# APPLICATION FOR APPEAL

### FIRE INSPECTION CORRECTION NOTICE

RE: 497 OTIS AVE  
Residential Class: C

### **Items for Appeal on the Fire Inspection Correction Notice "Deficiency List"**

2ND FLOOR  
GUARD RAIL

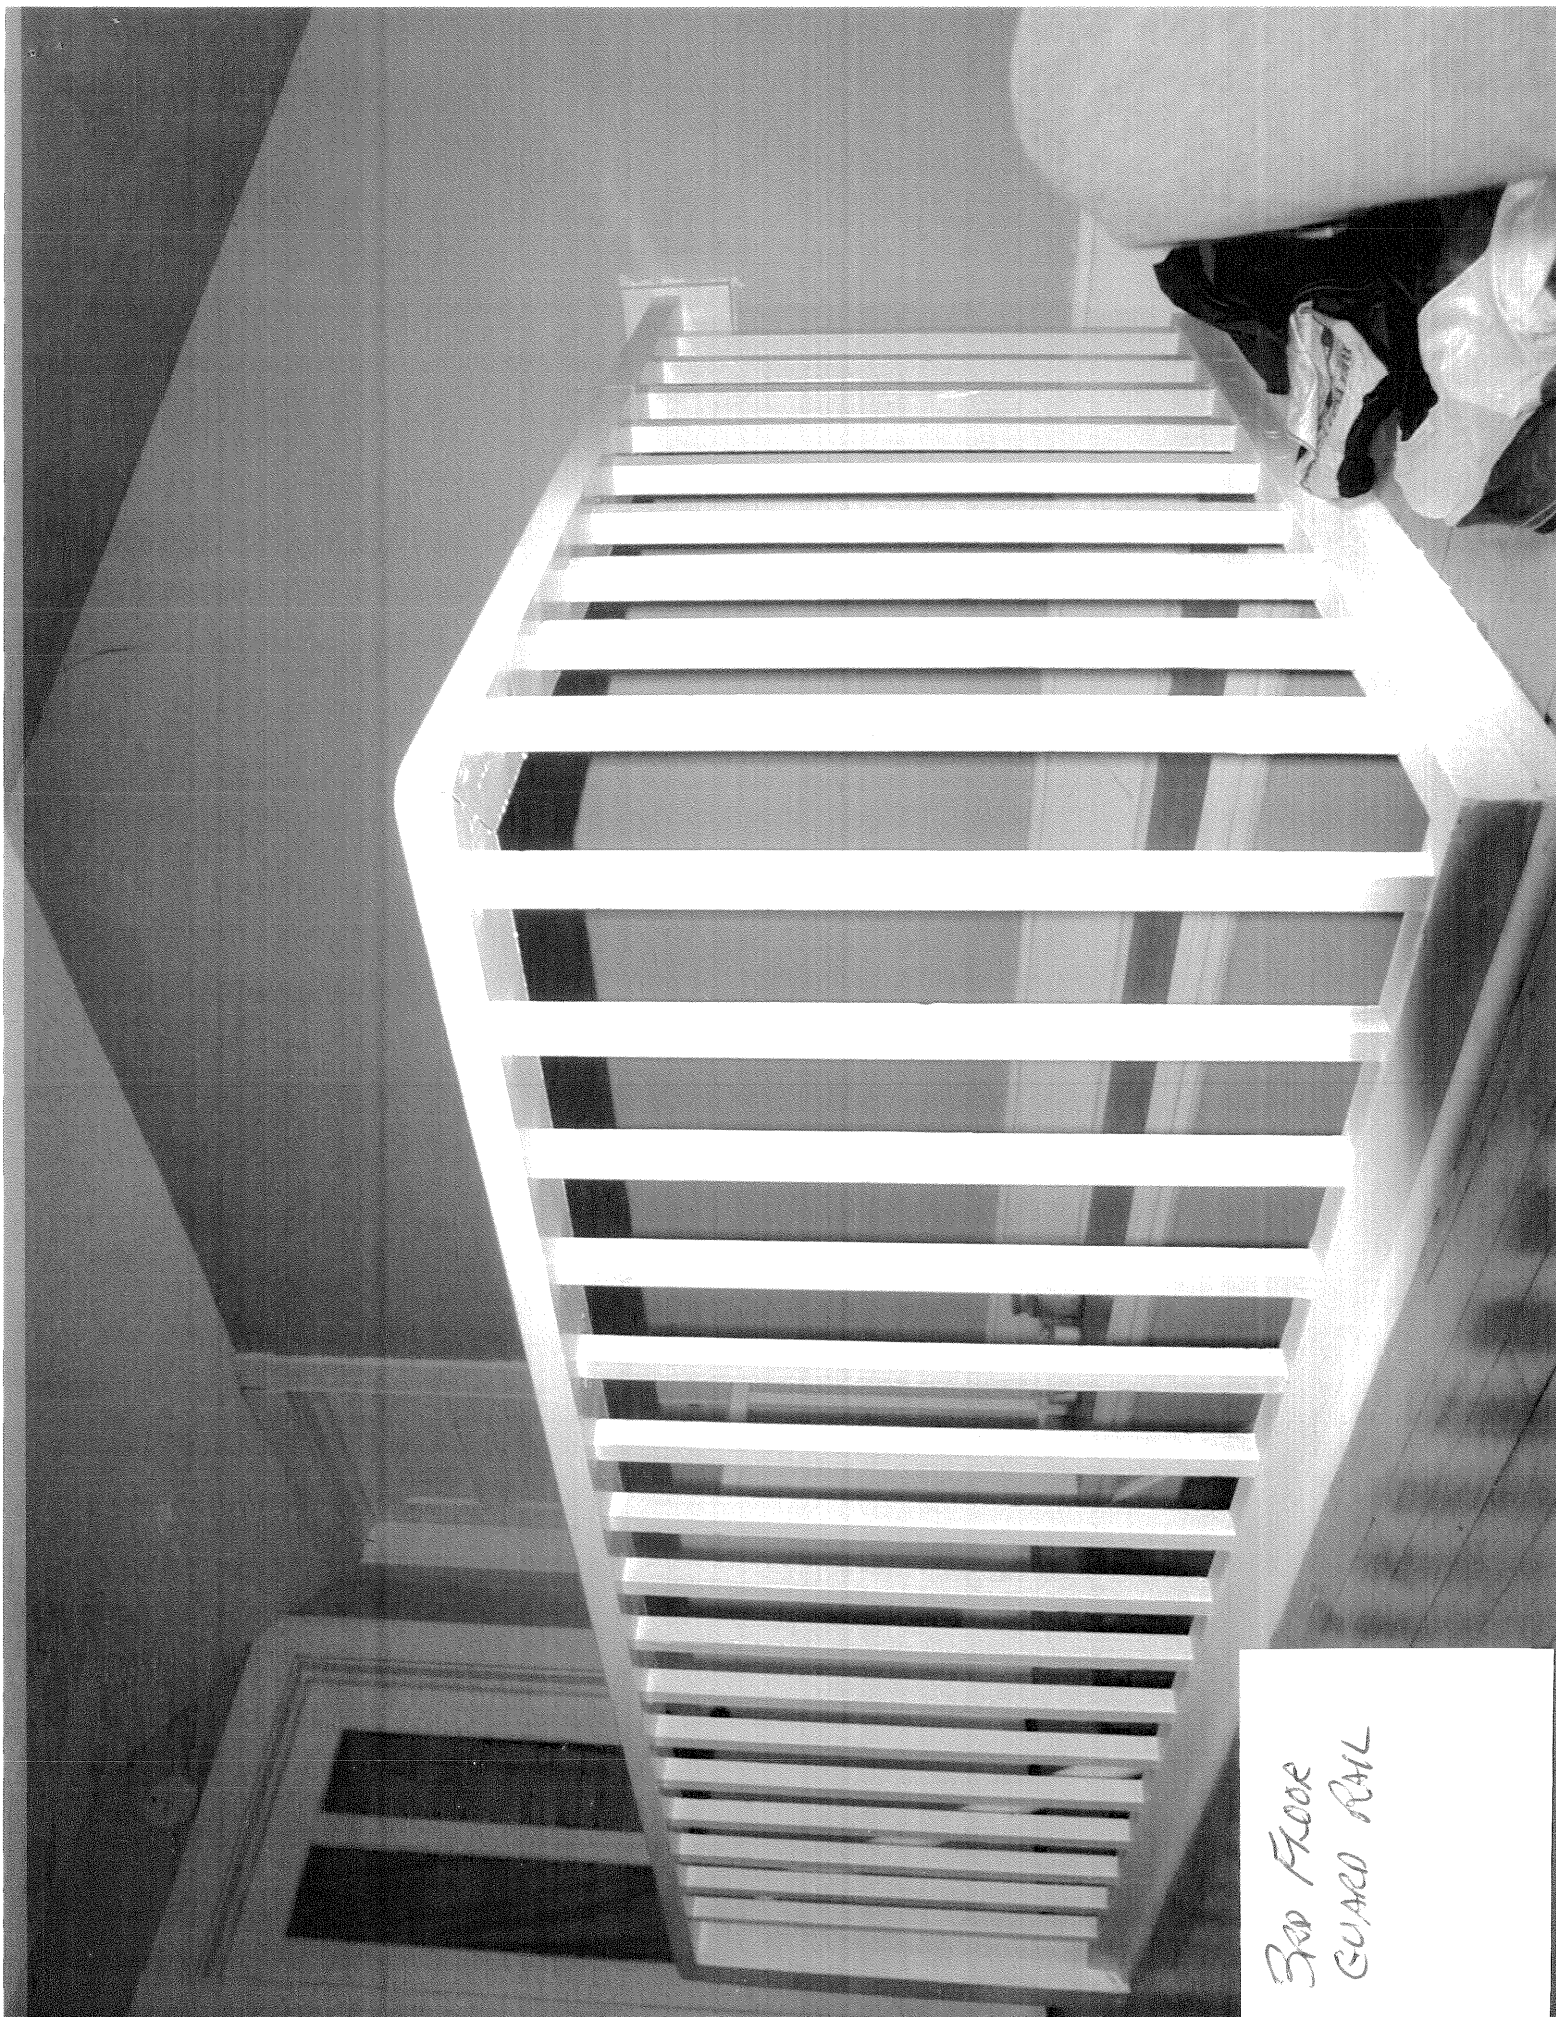
4. Garage and behind gas range - MSFC 605.6 - Provide electrical cover plates to all outlets, switches and junction boxes where missing.
5. Second and third floor stairways - SPLC 34.10 (3) 34.33(2) - Provide an approved guardrail. Intermediate ballustrade must not be more than 4 inches apart. Intermediate rails must be provided if the height of the platform is more than 30 inches.-Current guardrails are 29.5 inches.
6. Throughout - MN Stat. 299F.362 - Immediately provide and maintain a smoke detector located outside each sleeping area.-Maintain hard wired smoke detectors in an approved manner.

#### **Fire Inspection Deficiency List Item 5....2<sup>nd</sup> and 3<sup>rd</sup> Floor Stairways**

Sec. 34.10 (3) a. states, "Every stairwell must be maintained in accordance with the building code which was in effect when the stairs were originally constructed." This building is approximately 90 years old and has been very well maintained including the stairways.

The building has a flowing coherent architecture wherein the guardrail matches the stairwell window in style and finish. The decorative period guardrail is 30.5" above the hardwood floor deck. It is located in a very wide hallway brightly lit by a chandelier directly over the guardrail plus a huge window on the landing. (See Photo)

The third floor stairway guardrail is 29 ½ " above the hardwood floor in a very low traffic area where essentially no activity takes place and thus presents very limited exposure to anyone being careless enough to fall over the rail. (see photo)

I respectfully request that the railing be allowed to remain "as is" to function effectively as it has for the last 90 years and I will continue to maintain it in a sound condition.

I would request that this rail also be allowed "as is" with continued maintenance to maintain its current sound condition.

EXTERIOR ELEVATION - FRONT

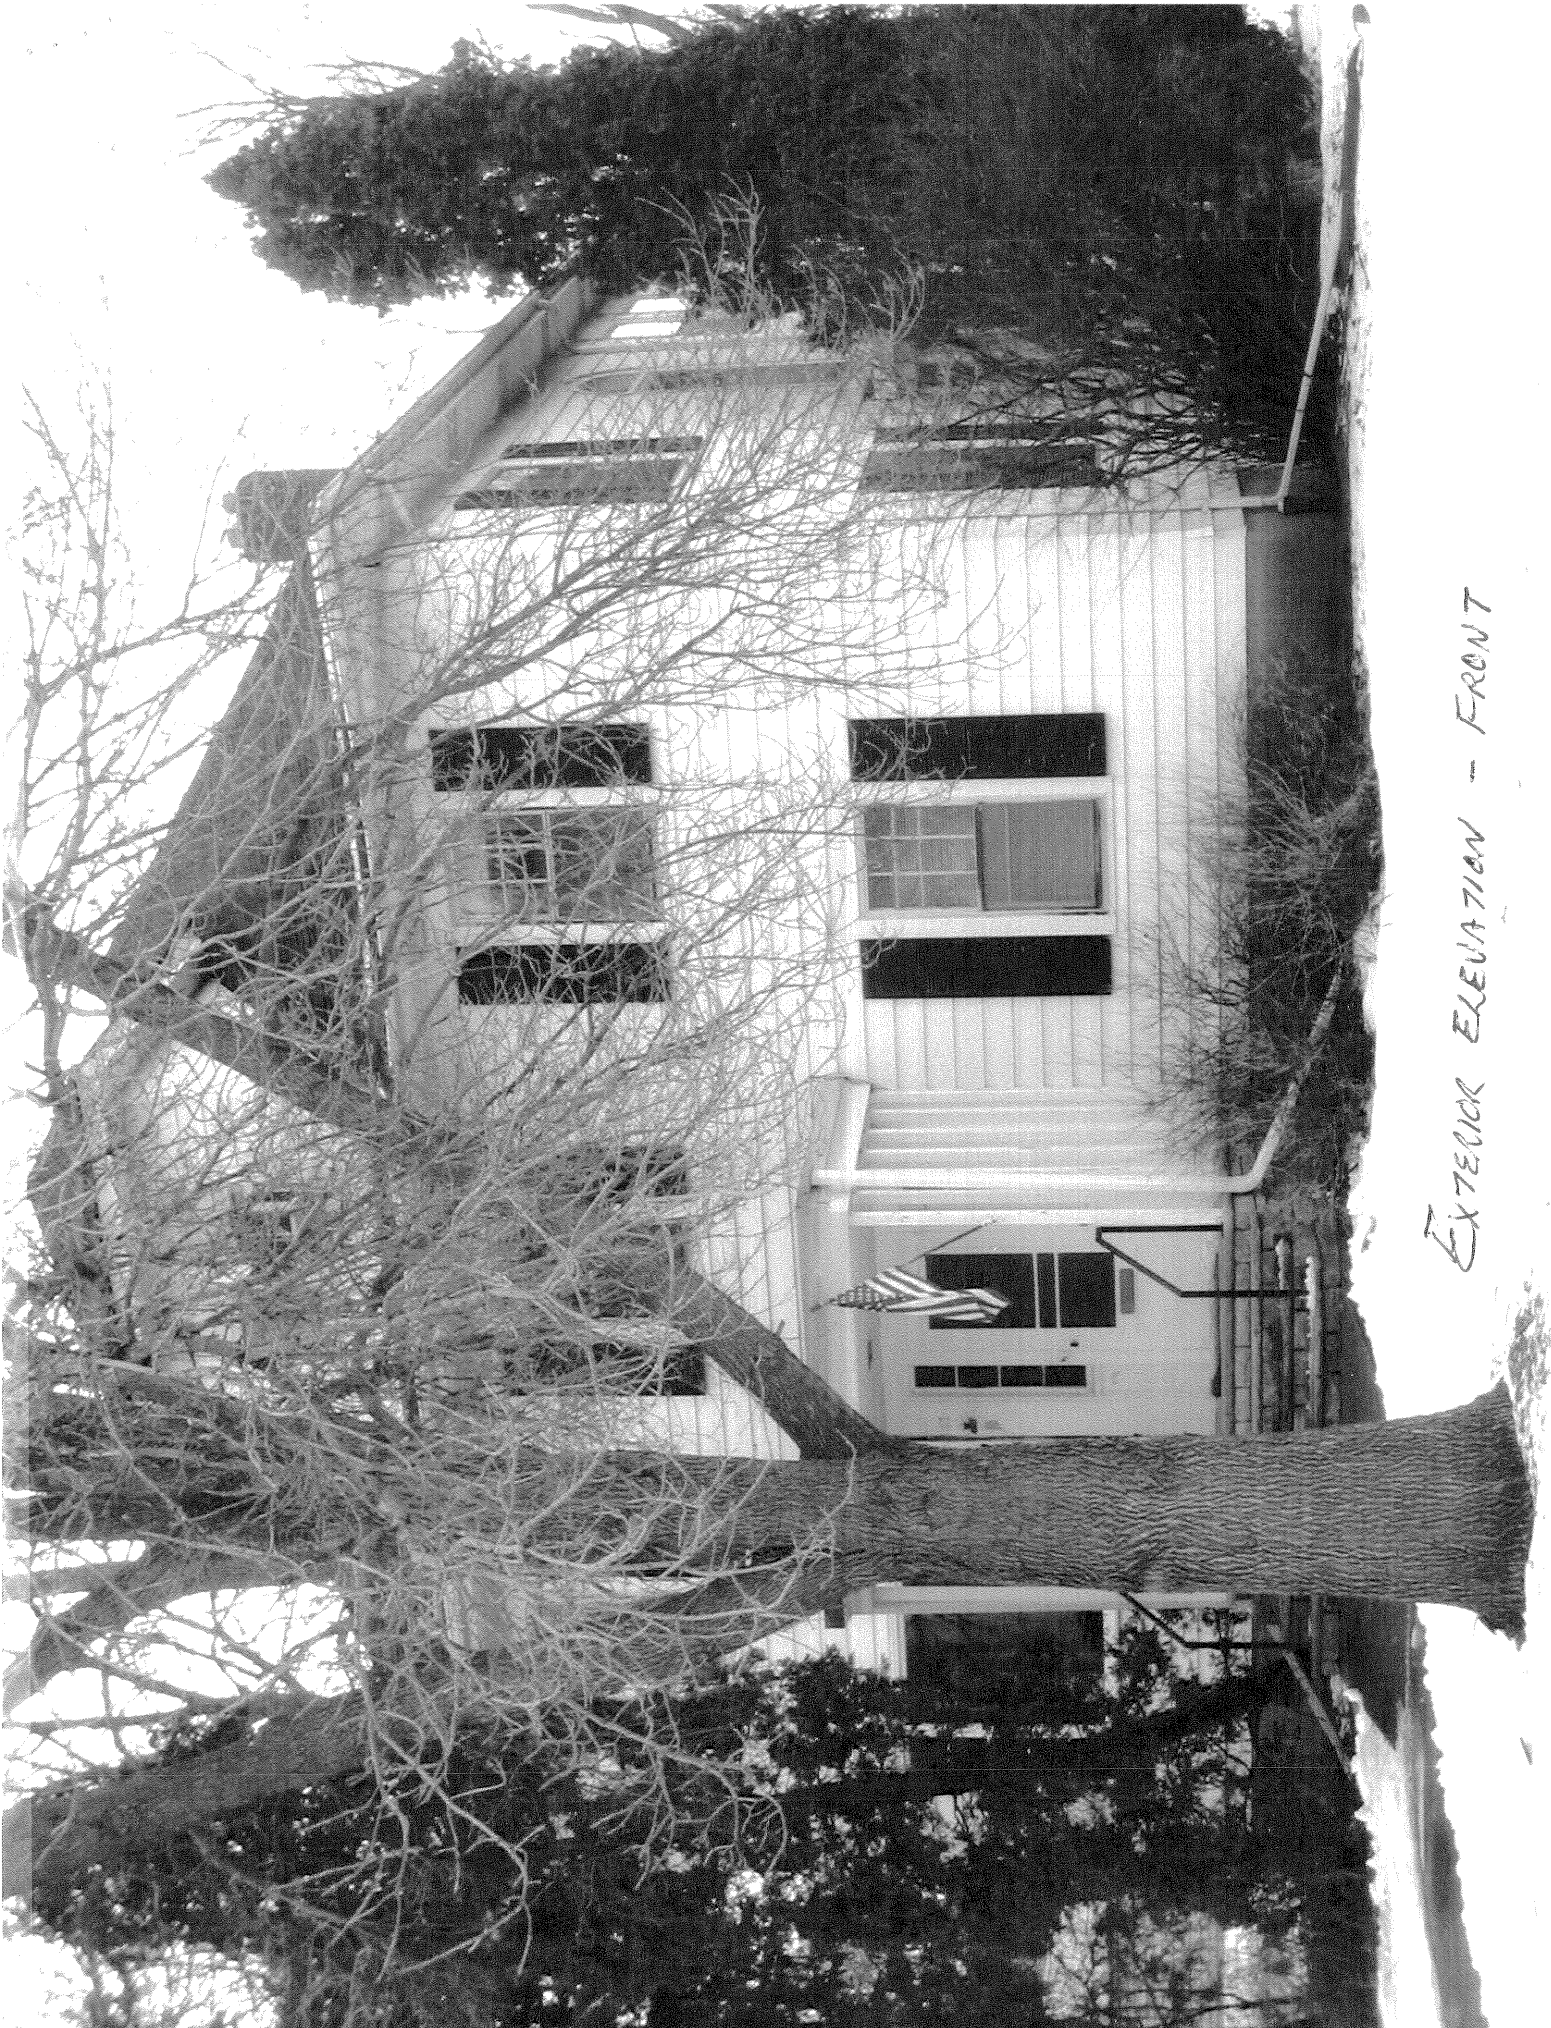
1. Basement - SPLC 62.101 - Use of this property does not conform to zoning ordinance. Discontinue unapproved use or call DSI Zoning at (651) 266-8989 to convert to legal use. Discontinue: Use of basement as a separate unit.
2. Basement living room - MSFC 605.4 - Discontinue use of all multi-plug adapters.
3. Double hung windows - MSFC1026.1 - Provide and maintain an approved escape window from each sleeping room. The minimum size must be 5 square feet of glazed area with a minimum of 24 inches of openable height and 20 inches of openable width. With a finished sill height not more than 48 inches. This work may require permit(s). Call DSI at (651)- 266-9090. Refer to the Escape Windows for Residential Occupancies handout for more information.-Upper unit second floor northeast

21.5 h x 33 w Glazed 10.4 sq ft  
Upper unit second floor north  
22 h x 29 w Glazed 8.3 sq ft  
Upper unit second floor northwest  
22.5 h x 31 w Glazed 9.0 sq ft  
Upper unit third floor  
23 h x 23 w Glazed 6.4 sq ft

### **Fire Inspection Deficiency List Item 3....Window sizes in sleeping rooms**

The windows all meet the requirement of at least 5 square feet of glazed area. As to the other dimensions, I am sure the current guidelines are what might be considered "ideal" dimensions for new construction. As vintage houses go in St Paul the windows in this building are probably larger than average. It is clear that these windows are adequate for anyone, even obese people to exit in case of an emergency.

Tearing a window out of each room and replacing it with a larger one would again destroy the exterior architecture of the structure thus degrading the value of St Paul housing stock for very little gained in terms of risk abatement.

I request that the windows be allowed to remain "as is" based on all of them having met the code in effect at the time the house was built.
